AMENDMENT  
U.S. Appln. No. 09/782,201

**AMENDMENTS TO THE DRAWINGS**

The attached drawing sheet includes a change to FIG. 2. The sheet replaces the original sheet (sheet 1 of 1) including FIGS. 1 and 2. In FIG. 2, the caption "PRIOR ART" has been added.

**FIG. 1****FIG. 2**

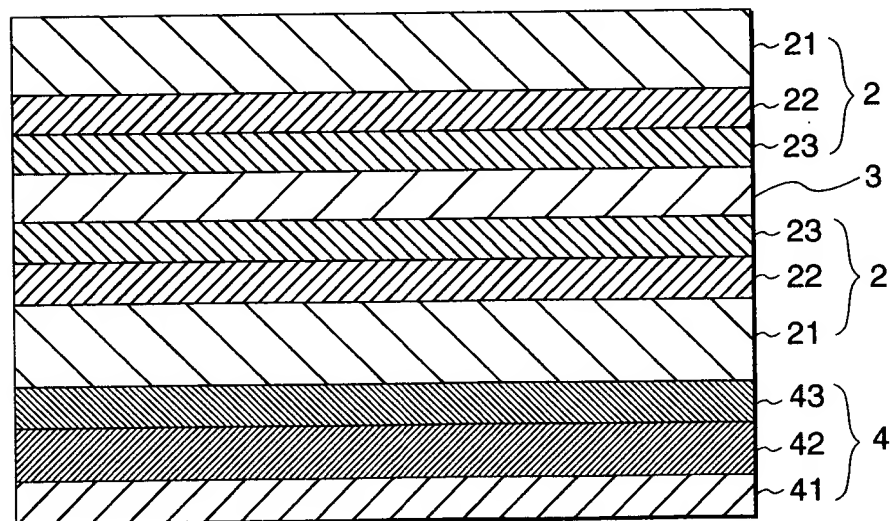
Referring to the second paragraph at page 2 of the Office Action, the examiner has objected to FIG. 2. Specifically, the examiner requests that FIG. 2 be amended to contain a legend, such as "Prior Art." According to the examiner, only that which is old is illustrated in FIG. 2.

In response, FIG. 2 has been amended by inserting therein the legend "Prior Art," which is supported by, for example, the description at page 4, lines 15-16, of the specification.
